Official Transcript of Proceedings
NUCLEAR REGULATORY COMMISSION

Title: Advisory Committee on Reactor Safeguards
 APR1400 Subcommittee

Date: June 5, 2017

APR1400 DCA

3.9.5 Reactor Pressure Vessel Internals (2/2)

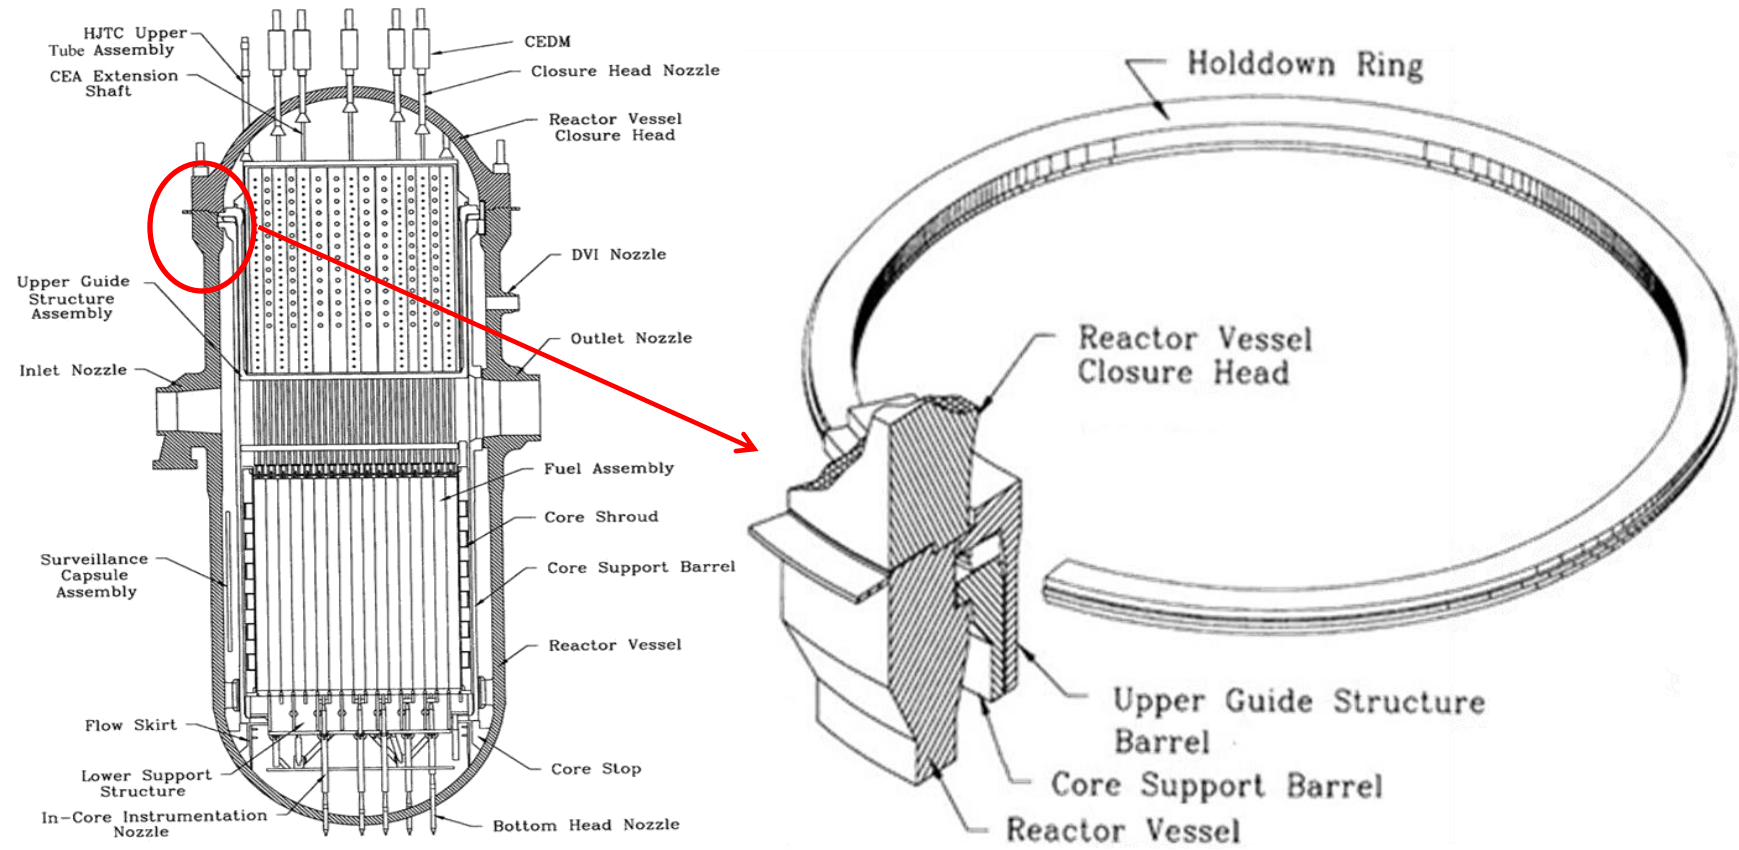
1 MEMBER SKILLMAN: Before you change this
2 image, and Andy, thank you for including this in the
3 presentation, KHNP, thank you for including this.

1 MEMBER SKILLMAN: They are? So, when you
2 remove your reactor vessel head, does the core support
3 assembly rise?

7 MEMBER SKILLMAN: Okay. That answers my
8 question. Where I was really going with this is to
9 understand how the internals are, on the one hand,
10 free to float until you place the reactor vessel head
11 in place.

20 This question he was drawing out for you,
21 we've talked during LOCA analysis and somewhere it's
22 up to 15 about this bypass flow from the upper plenum
23 to the downcomer that relieves loop seals and other
24 things that happen with LOCA.

1 figure where this bypass happen? Anybody know? You
2 do?

15 MEMBER SKILLMAN: The answer is the
16 springs on the fuel assemblies --
